# UNITED STATES PATENT AND TRADEMARK OFFICE

APPLICATION NO.	FILING DATE	FIRST NAMED INVENTOR	ATTORNEY DOCKET NO.	CONFIRMATION NO.
09/989,271	11/20/2001	Michael C. Smyk	FCI-2632/C3069	9590
48580	7590	11/18/2005	EXAMINER	
WOODCOCK WASHBURN, LLP ONE LIBERTY PLACE - 46TH FLOOR PHILADELPHIA, PA 19103			HARVEY, JAMES R	
			ART UNIT	PAPER NUMBER
			2833

## Office Action Summary

## ***DETAILED ACTION***

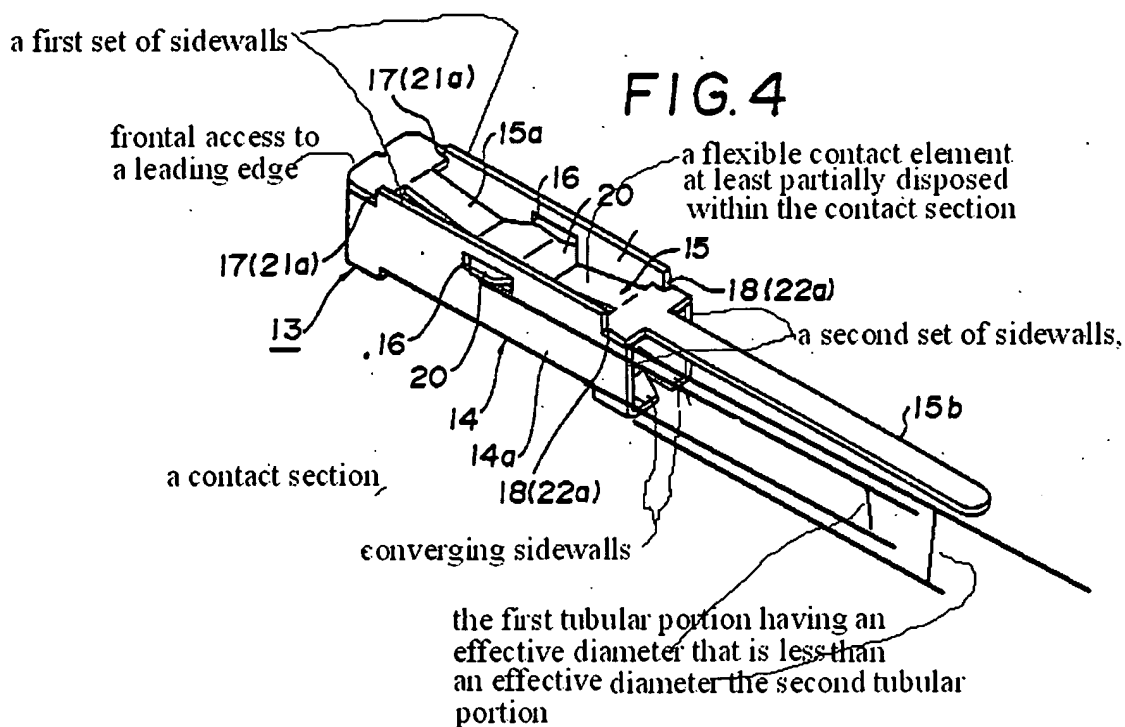
-- In reference to Claim(s) 45, Shima shows (see examiner's figure)

-- In reference to Claim(s) 46, Shima shows (see examiner's figure) the flexible contact element includes a leading edge (see examiner's figure) that is positioned outside of the contact section.

-- In reference to Claim(s) 48, Shima shows (see examiner's figure)

-- In reference to Claim(s) 49, Shima shows (see examiner's figure) the flexible contact element includes a leading edge that resides outside of the contact section.

-- In reference to Claim(s) 50, Shima shows (see examiner's figure)

-- In reference to Claim(s) 51, Shima shows (see examiner's figure)

-- In reference to Claim(s) 52, Shima shows (see examiner's figure)

-- In reference to Claim(s) 53, Shima shows (see examiner's figure)

-- In reference to Claim(s) 54, Shima shows (see examiner's figure)

a contact section including a set of converging sidewalls that define an insertion pathway for a complementary male terminal,' the insertion pathway having a diameter that is smaller than a tubular portion that is proximate the set of converging sidewalls', and

a flexible contact element partially disposed within the contact section in a non-fixedly secured manner so that opposing ends of the flexible contact element are free. for urging a complementary male terminal into engagement with a contact section bottom wall;

wherein the female electrical terminal is devoid of any structure prohibiting frontal access to a leading edge of the flexible contact element, and

wherein the flexible contact element does not extend into the set of converging sidewalls.
